**EVALUATION STUDY OF REPORTS**  
**SUBMITTED BY**  
**BUREAU VERITAS INDIA PVT LIMMITED**

# **STRUCTURAL STABILITY ASSESSMENT OF EXISTING CHANDERKUNJ ARMY RESIDENTIAL TOWER-B & C OF ARMY WELFARE HOUSING ORGANIZATION (AWHO) AT SILVER SAND ISLAND, VYTTILA, KOCHI, KERALA**

(IND.B.7.2022.300DR-R3)

## EVALUATION OF BVIL REPORT MAY 2023

**Fig 1.** Individual UPV test results on shear wall in Tower-C as per details in table above.

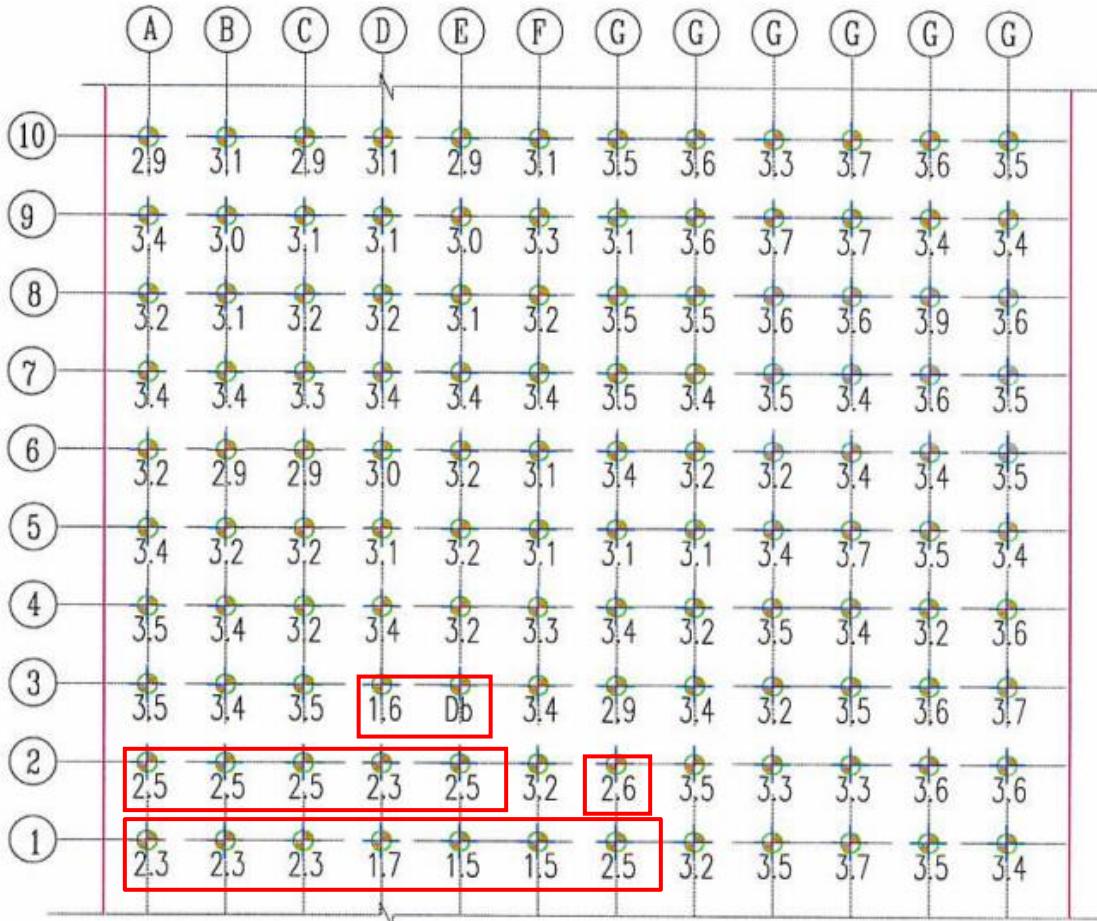
**Note:** The portion of the member marked in red is a region within the member which could be having internal flaws or micro-cracks

14. This brings out another important aspect, that is, the selection of the sample location in the concrete member. From Fig. 1, it may be observed that the area having internal flaws would vary depending on the selection of the test location based on visual inspection. If there is any deliberate attempt to avoid any particular distressed location based on visual inspection, the validity of the result would be adversely affected. In the present BVIL report, there is no mention about the methodology of sample selection, hence the validity of the test results cannot be established.

**Fig 2 a & b.** Equipotential contour map and cumulative frequency distribution diagram, which are used for depicting the results of half-cell potential tests by Indian and American codes.

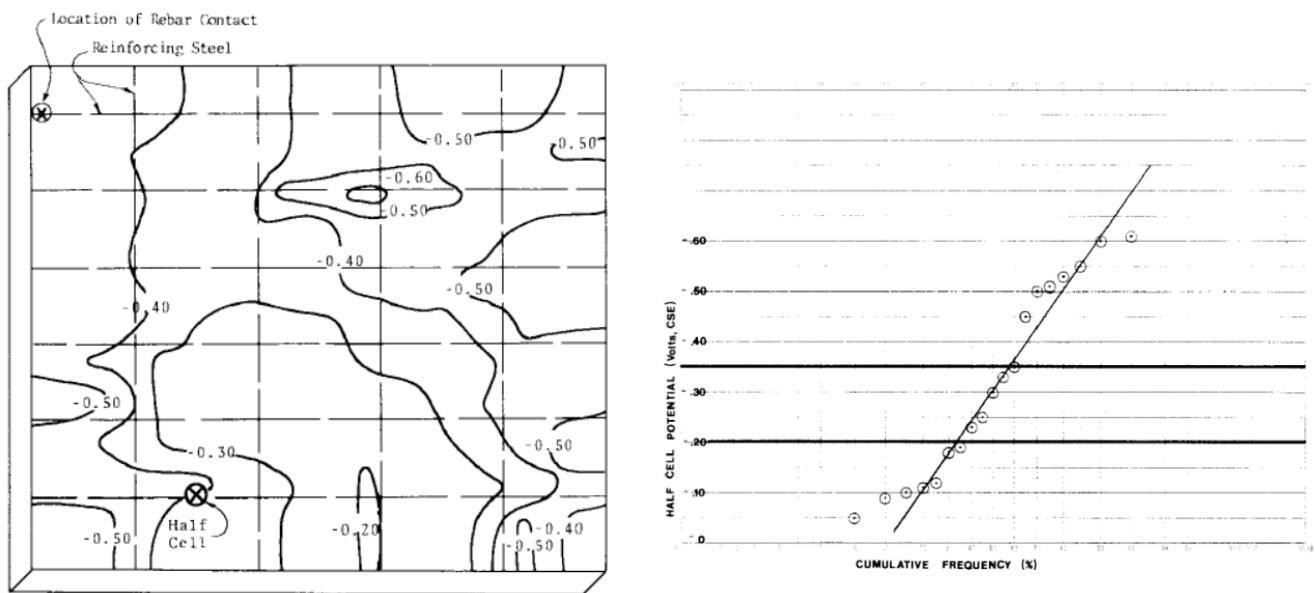
30. As per both IS and ASTM Codes, the test results are supposed to be depicted in the form of **Equipotential Contour Maps** or **Cumulative Frequency Distribution Diagrams** (see representative figures below). However, the report has just depicted the readings in tabular form with likely corrosion possibilities.

- (b) The presentation and assessment of the results **do not align with the stipulations outlined in either Indian or American codes**. The study has not adopted the recommended methods such as **Equipotential Contour Maps and Cumulative Frequency Distribution** for result analysis.
